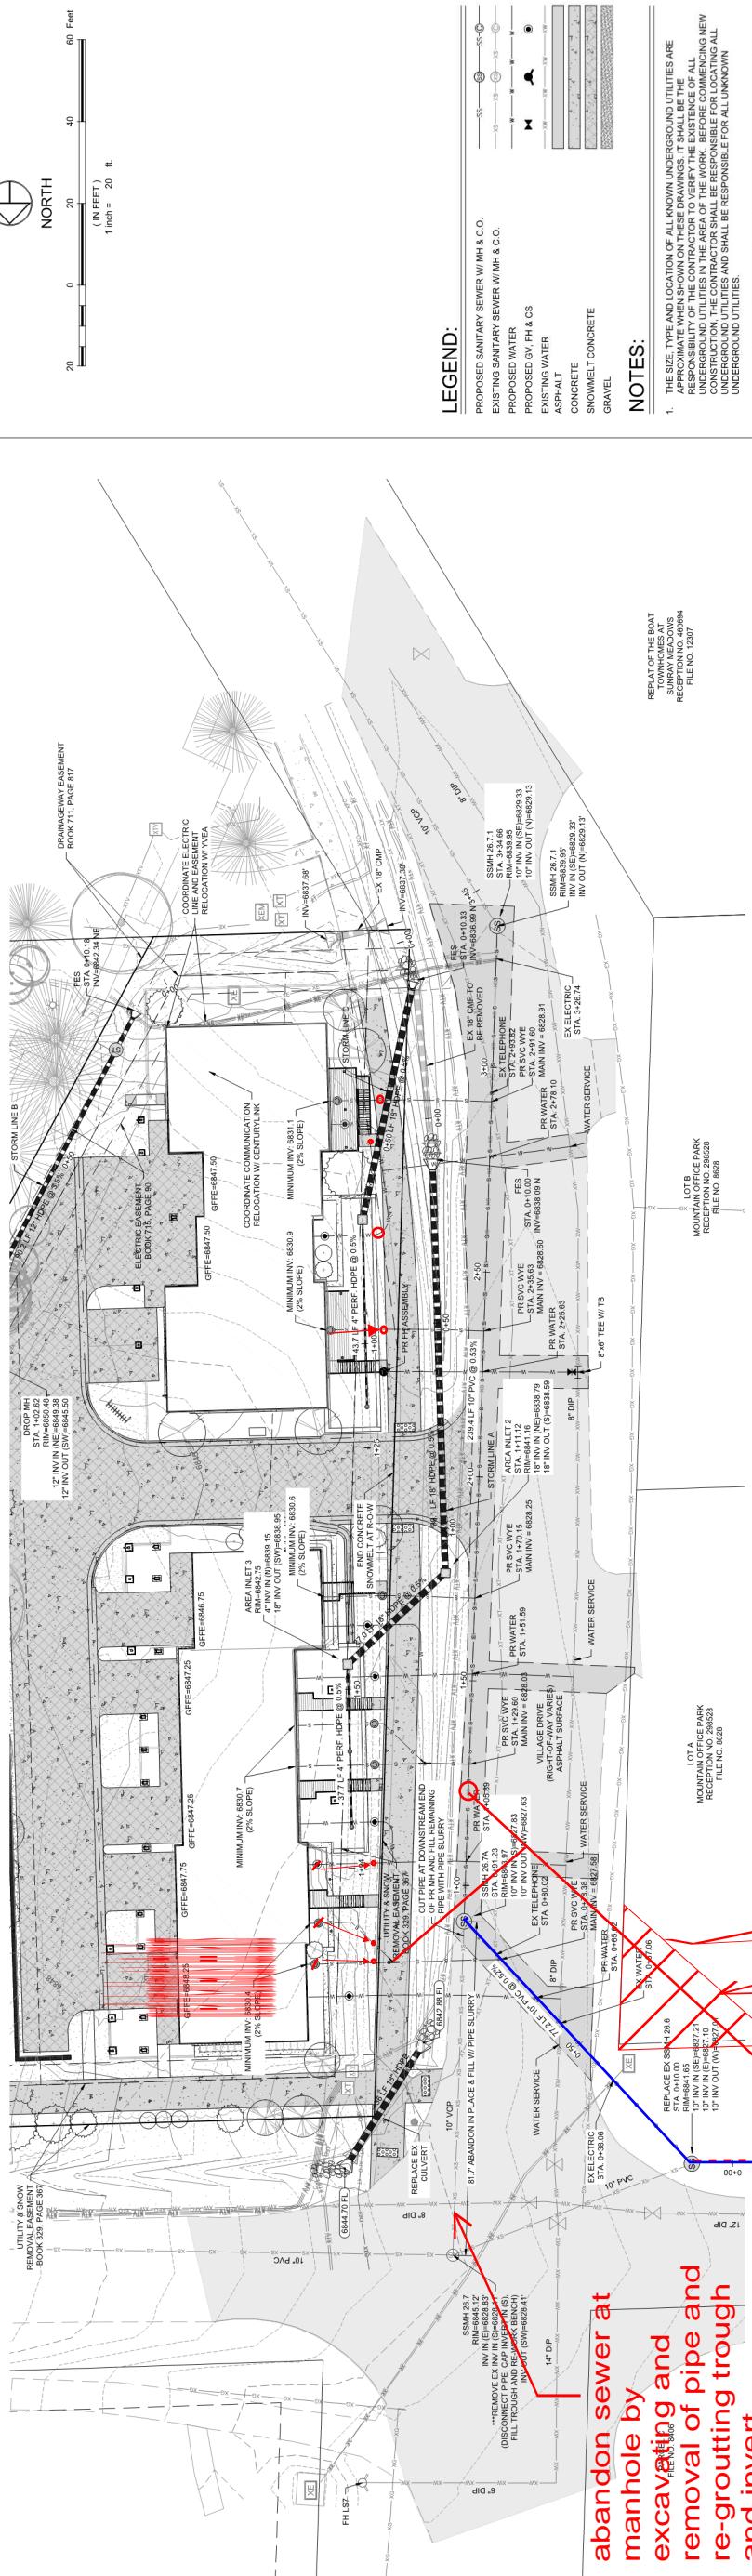
abandon sewer at manhole by excavating and removing of pipe and re-grouting trough and invert.

Alternate alignment at deeper depth per conversation with Ryan Spaustat.

Assessment to be provided by
Joining development permit
Initially in process.
